VILLAGE OF HOMEWOOD

MEMORANDUM

Topic: Case 26-72: Mixed-Use Building Renovation/Expansion at 1722 Ridge Road

Figure 3: Schematic View of the proposed building design at 1722 Ridge Road. (Source: Drawings provided by Applicants)

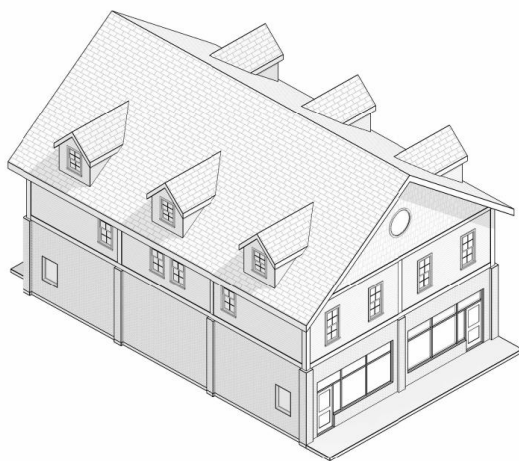
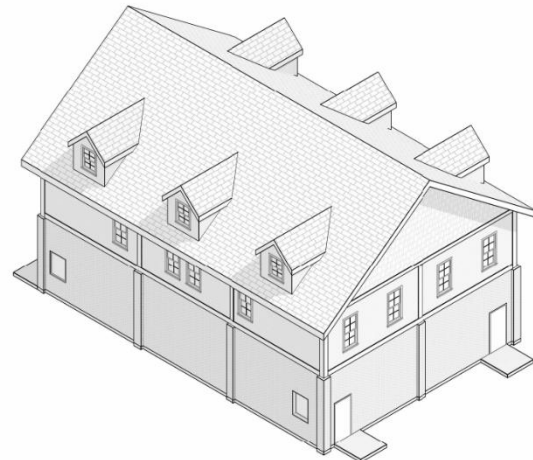
The proposed building design calls for use of building materials (vinyl siding) prohibited in the Village Zoning Ordinance. The Appearance Commission may allow prohibited materials upon approval with other required approvals by the Planning and Zoning Commission.

Staff has reviewed the design against the standards set forth in the Appearance Plan and finds that the use of the material will not adversely impact surrounding property or the overall architectural character of the area. Staff has provided a recommendation to permit the use of the proposed vinyl building material. *See Recommended Appearance Commission Action.*

Proposed Building Design: Much of the existing building on the subject property will remain. The masonry work is proposed to be restored and colored white/tan. Accent features (such as window and door frames) will be colored black. All structural elements (including the masonry columns) on the existing building will remain and will be incorporated into the new structure.

The proposed building addition above the existing building takes queues from the Craftsman (Arts and Crafts) style of construction. Design features reflecting this style include a large gable end facing Ridge Road which will be clad in wood shake siding, large overhanging eaves along the roofline, and the use of numerous dormers along each side of the gable roof.

4. Vinyl siding shall be approved as a permitted material, subject to additional approvals as required by Village staff and the Planning and Zoning Commission.
